# Submission to the Draft Amendment GC206 – Small Lot Housing Code Update

August 2022

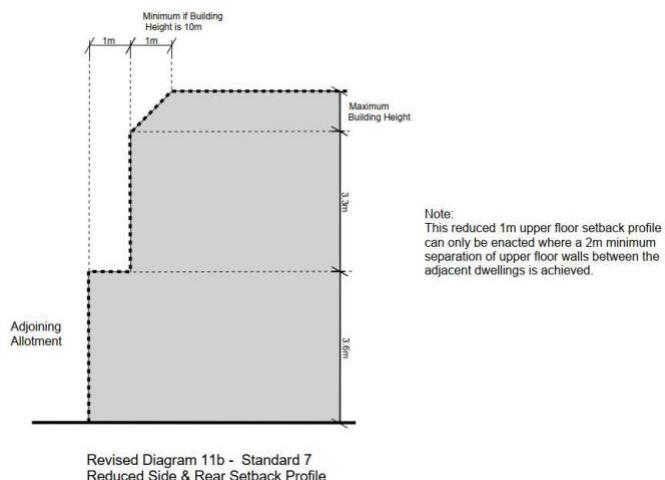
18. We propose an additional amendment to Standard 7 Side and Rear Setbacks relating to the side setback. We recommend this be amended as shown in the image below so that it is reduced to one metre for simultaneously approved dwellings between 3.6 metres high and 6.9 metres high, rather than the angled setback created by the current requirements. This will allow for more design variation and product diversity that encourages built form separation.
